## SIB 52 24 19

### RECALL 19V-823: ISOFIX CHILD SEAT ANCHORS

This Service Information Bulletin (Revision 2) replaces SI B52 24 19 **dated January 2020**.

BMW of North America, LLC is conducting a Voluntary Safety Recall (effective November 18, 2019) on Model Year 2015 through 2019 BMW X6 and X6M vehicles that were produced from Start-of-Production through May 2019.

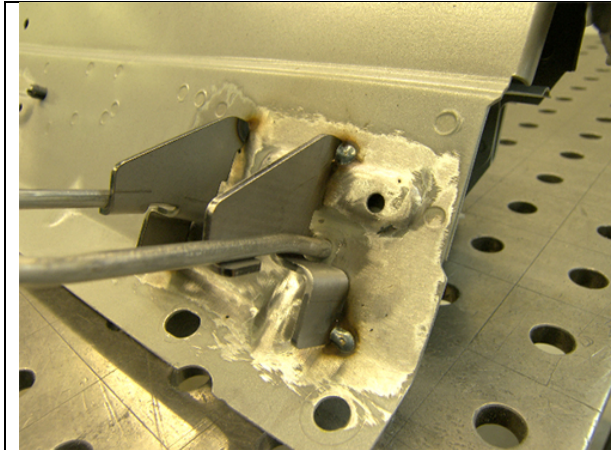
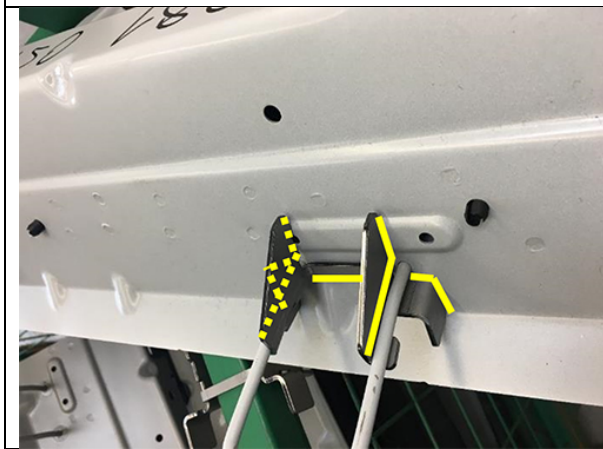
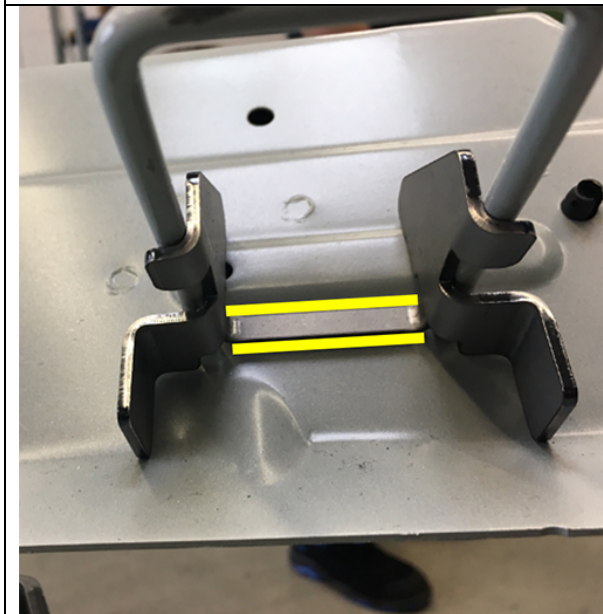
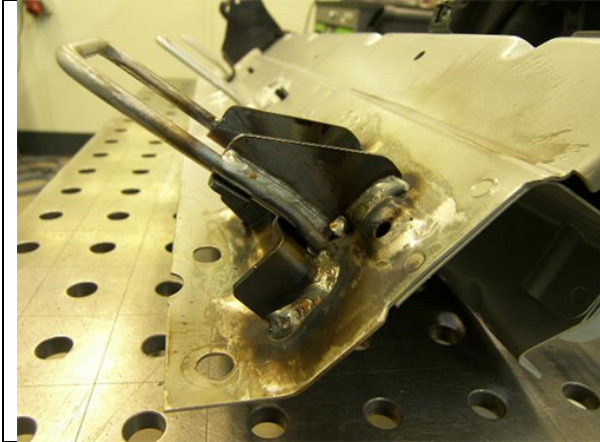
|  | <p>12. Position the 4 new reinforcement brackets to ISO-FIX bracket as shown.</p> <p><b>(P/N 52 20 4 A08 D40)</b></p>  |

13. Position new reinforcement bracket to ISO-FIX bracket as shown

14. Position new reinforcement bracket to ISO-FIX bracket as shown

15. Once bracket position is correct, and it sits flush as indicated in the three previous pictures, then you can tack weld the bracket into place.

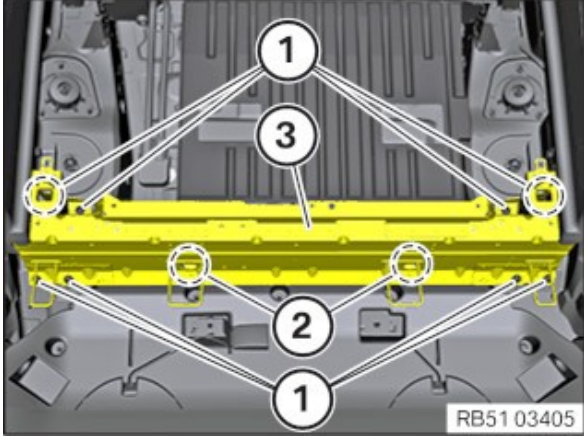
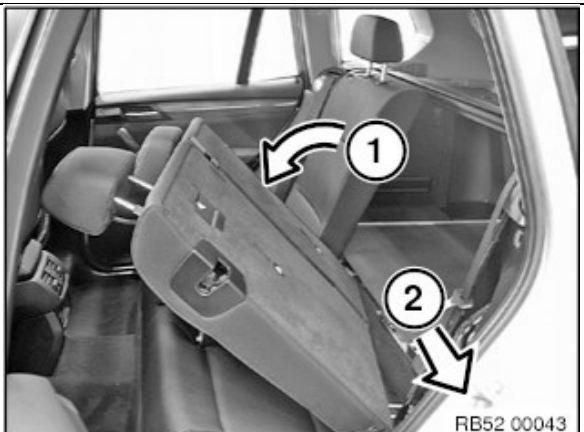
16. A continuous weld bead should be applied at the yellow lines.

17. A continuous weld bead should be applied at the yellow lines.
